**2024 SMP Package V (Scale St, Venice St)
Solicitation No. CO-00669
Job No. 22-5043 (Water)**

**ADDENDUM 1
August 17, 2023**

VENICE ST WATER PLAN (1 OF 5)

MAP No. _____ SHEET 8

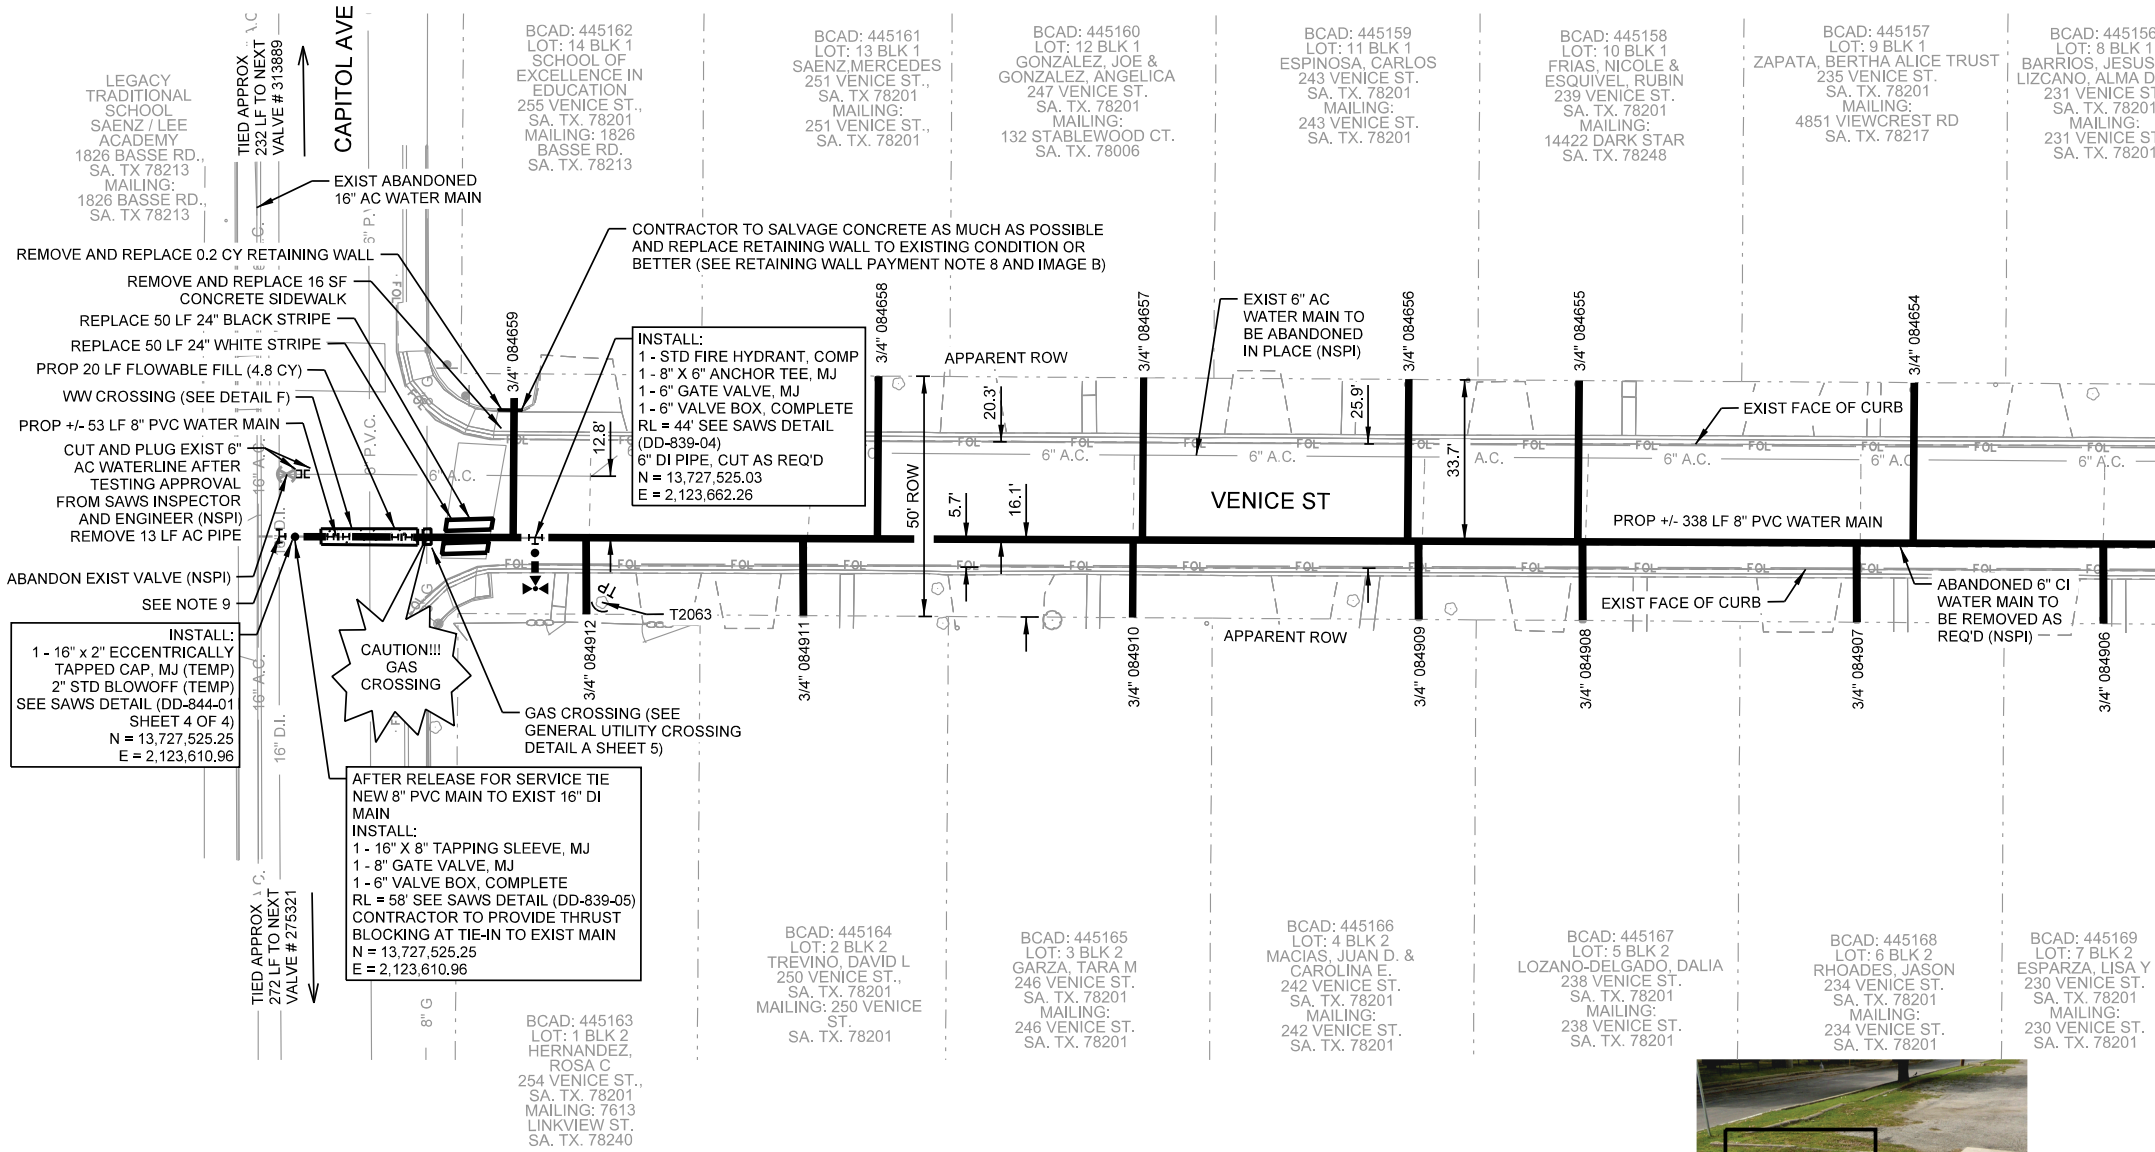
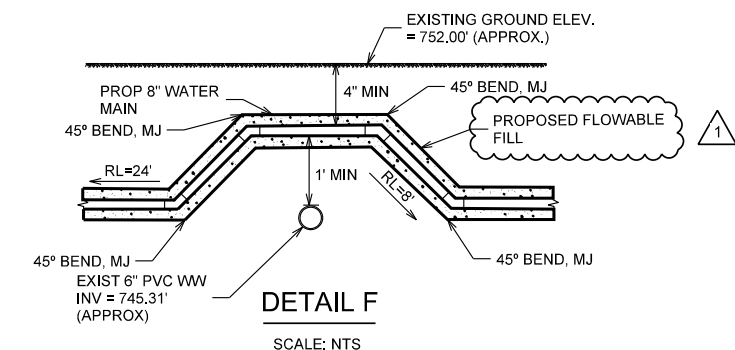
- 1. Remove sheet 8 and replace with the one attached to this addendum dated 8/09/2023. Bidders to note that a callout in Detail F was revised which is clouded on the revised sheet.**
